Cedar Grove, Block 3, Lot 5R (Replat)

**Request for Plat Waiver
from the Sidewalk Construction Requirement**

**Planning Commission Meeting
October 27, 2021**

Cedar Grove,
Block 3, Lot 5R

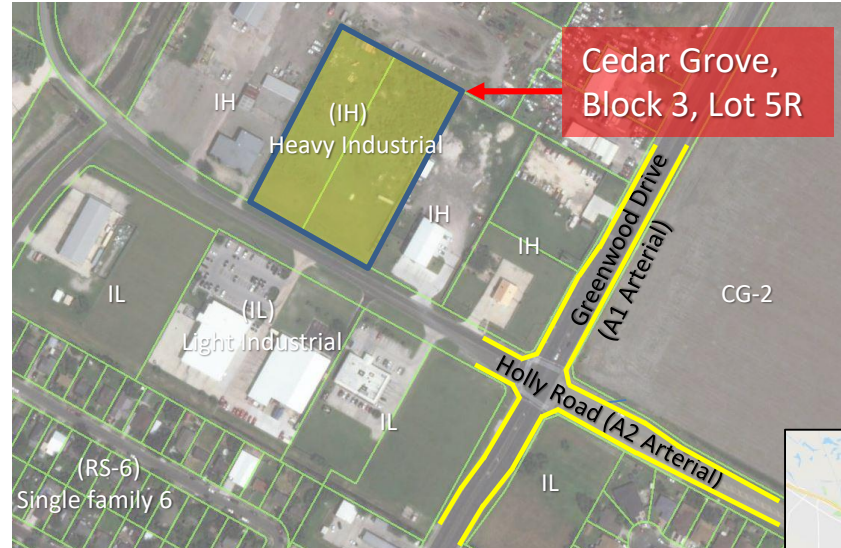
- Holly Road is categorized as an A2 Secondary Arterial street in the Urban Transportation Plan (UTP). UDC Table 8.2.1.C requires sidewalk along Arterials.
- The area is zoned IH (Heavy Industrial). Sidewalk is required in industrial subdivisions along streets that are in the UTP as arterials or collectors, and also along "through-streets" that either are connecting to existing streets or to proposed arterials or collectors, per UDC 8.2.2.A.1.a.i and ii.
- None of the exceptional conditions for a sidewalk waiver that are listed in UDC 8.2.2.C exist in this case.
- There is an established sidewalk connection along Holly Road at the nearby intersection with Greenwood Drive.

Weighing the factors, Staff recommends denial of the request for waiver from the sidewalk construction requirement
